# UNITED STATES PATENT AND TRADEMARK OFFICE

APPLICATION NO.	FILING DATE	FIRST NAMED INVENTOR	ATTORNEY DOCKET NO.	CONFIRMATION NO.
10/605,852	10/30/2003	Martin Weiss	20073	2851

**Office Action Summary**

6. Claims 15-18, 21, and 22 are rejected under 35 U.S.C. 102(b) as being anticipated by Yamashita (US Patent No. 5,946,978).

Fig. 3

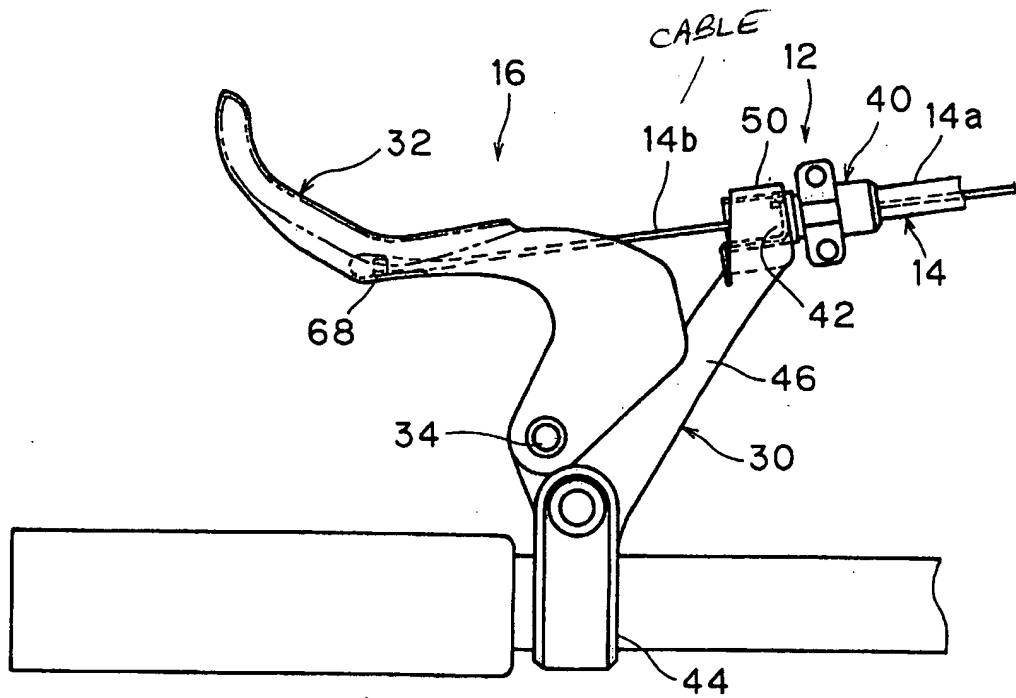
Regarding claim 16, the detent contour 62 has a non-round cross section (since the contour 62 is a longitudinally extending slot) and is configured such that the retention segment 93 has freedom to deflect, the retention segment 93 is configured to extend substantially parallel with the control cable 14b extending through the adjuster 50. See Fig. 3.

Fig. 4

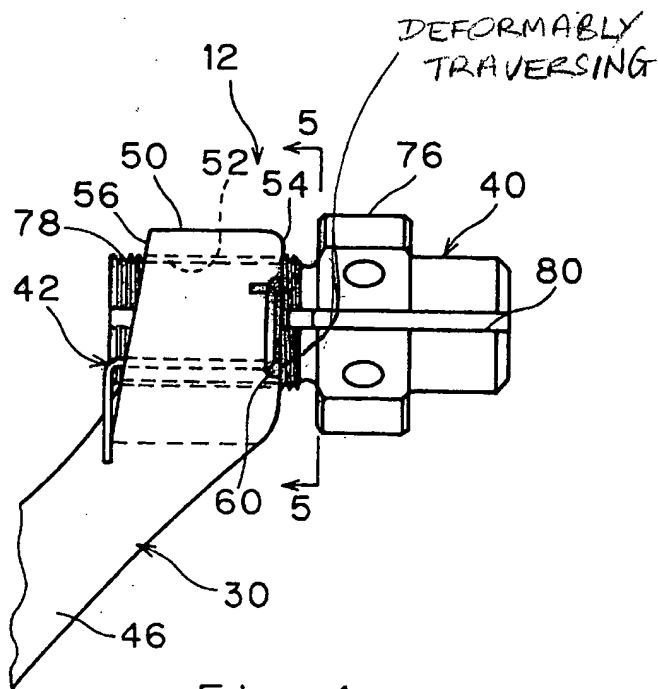
a detent mechanism including a detent contour 62 (*id.* col. 5, line 56 through column 6, line 24) extending along a radial interior surface (Figs. 4-7) of the adjuster 50 and a spring element 42 having at least one retention segment 93 and a support segment 95, the retention segment 93 of the spring element 42 *deformably traversing along* the detent contour 62 (at its bent portion as best seen in Fig. 4 of the Attachment. *Ibid.* col. 6, lines 14-34), the support segment 95 of the spring element 42 supported by the housing 40 (Fig. 5).

The Examiner respectfully submits that Applicant's contention is unsupported by the substantial evidence in the record. In fact, Yamashita teaches the element 50 that has a detent contour 62 wherein the retention segment 93 of the spring 92 engages the contour 62 *from within* the element 50. Moreover, one end of the retention segment 93, which is connected with the support segment 92/95, is bent transversely to the detent contour as seen in Figs. 4 and 5 so that
